Proposed PCS Text for tx_mode=SEND_S

Berlin, Germany

March 9, 2015

Figure 97-mm --- SEND_S PN sequence generator by linear feedback shift registers S_n

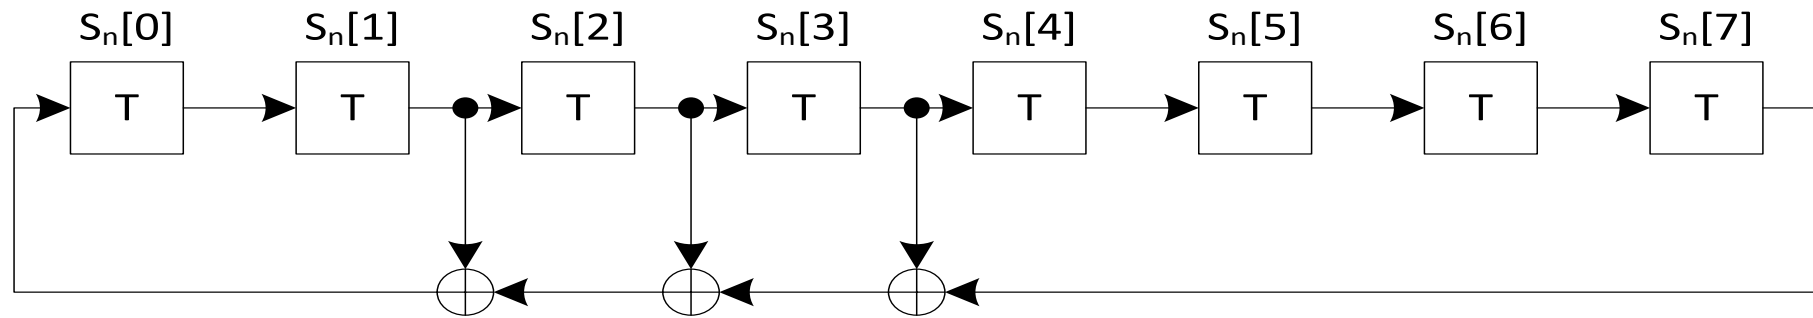
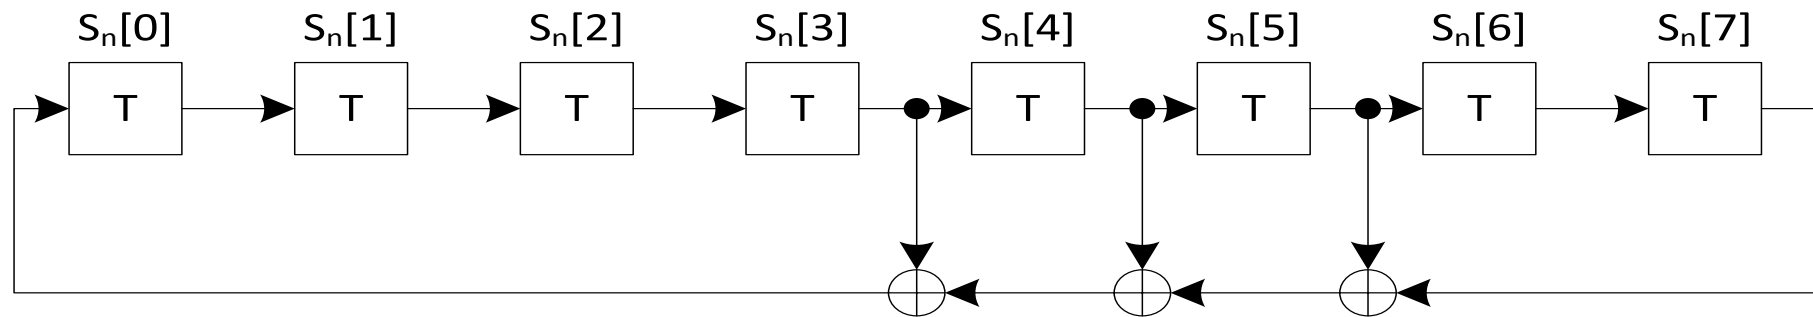
An implementation of MASTER and SLAVE PHY SEND_S PN sequence generators by linear-feedback shift registers is shown in Figure 97-mm. The bits stored in the shift register delay line at time n are denoted by $S_n[7:0]$. At each symbol period, the shift register is advanced by one bit, and one new bit represented by $S_n[0]$ is generated.

#3 Add Figure 97-mm close to 97.3.5a

The PN sequence generator shall be reset upon execution of the PCS Reset function, or whenever tx_mode value changes to SEND_S from any other values. If PN sequence generator reset is executed, all bits of the 8-bit shift register may be set to arbitrary values except for all zeros.

The bit $S_n[0]$ is mapped to the transmit symbol T_n as follows: if $S_n[0] = 0$ then $T_n = +1$, if $S_n[0] = 1$ then $T_n = -1$.
